Cc: Brian Bateman <Brian.Bateman@kitchener.ca>
Subject: Circulation for Comment - 7 Morrison Road (OPA/ZBA)

City of Kitchener
COMMENT FORM

Project Address: 7 Morrison Road
Application Type: Official Plan Amendment OPA22/013/M/BB
Zoning By-law Amendment ZBA22/024/M/BB

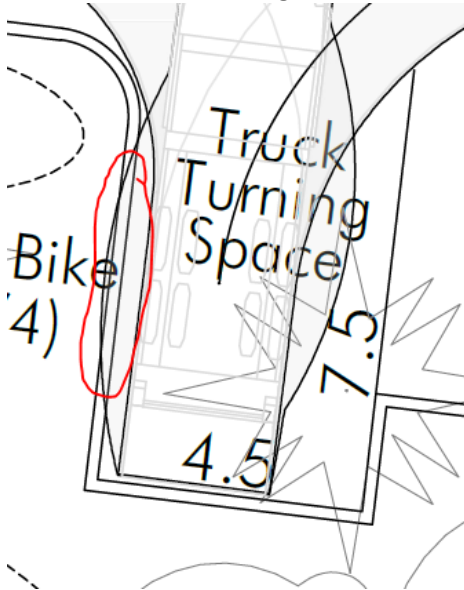
- b. The Garbage Truck Turning Movement 1 plan submitted by MHBC for the “Wayne Titan” design vehicle illustrates a conflict with the concrete curbing noted below in red. Transportation Services recommends correcting this conflict.
